MFN 09-319 Revision 1

Subject: **Response to Portion of NRC RAI Letter No. 328 Related to ESBWR Design Certification Application – Piping Design; RAI Number 3.12-3 S04 Revision 1**

RAI Number 3.12-3 S04¹ Revision 1

Figure B-3-5(a) Acceleration Time Histories for Vent Wall 701, and RPV Nozzle in N-S Direction from Time 7.5 sec. to 8.0 sec. (Not Correlated)

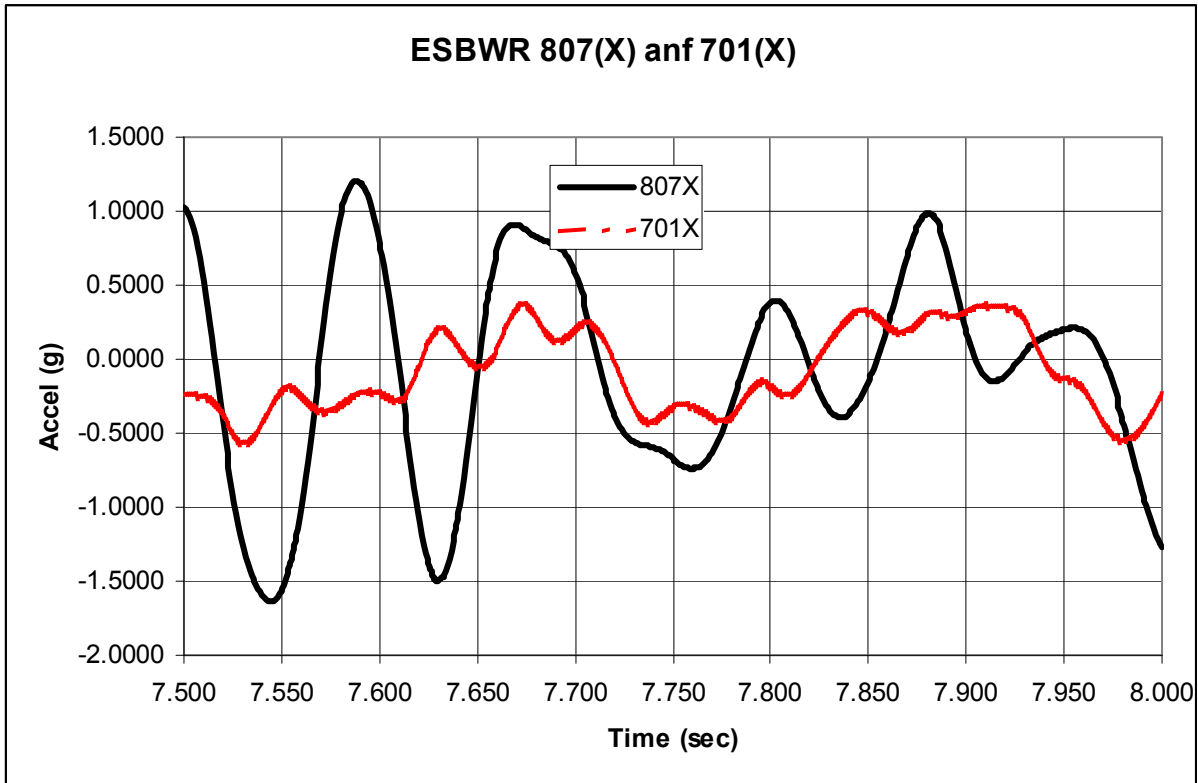
The staff also notes that Figure B-3-5 of the GEH study report, MFN 06-119, Supplement 2, (ML072680480) showed phase correlation in the vertical direction. How does this justify the use of the SRSS method?

Additional time histories plots for the RPV nozzle and vent wall in the horizontal directions, North-South (N-S) and East-West (E-W), are plotted to demonstrate that there will be no correlation in the horizontal direction when the piping is not supported by the same structure. These plots are presented with this RAI response: It is noted that the time period selected for the plots is between 7.5

Figure B-3-5 (a) - Acceleration Time Histories for Vent Wall 701, and RPV Nozzle in N-S Direction from Time 7.5 sec. to 8.0 sec. (Not Correlated)

The above four figures illustrate that in the horizontal direction the N-S and E-W time histories at the RPV nozzle and the vent wall are not correlated. Additional plots for Nodes 206 and 807 in the horizontal direction are also provided for reference. The necessary conditions to have correlated time histories are:

- (1) support points are on the same floor, that have exact the same mode shape and natural frequencies, or,
- (2) on the same concrete slab plus the member to the support points are rigid, such as the RPV wall and the vent wall are rigid in vertical direction.

Since the vertical direction for the cases evaluated in the study met these conditions, the comparison plots show that phase correlation was present, but since the other two directions were not correlated, the results of the study still demonstrates that the SRSS method was valid when the 10% adder was applied.
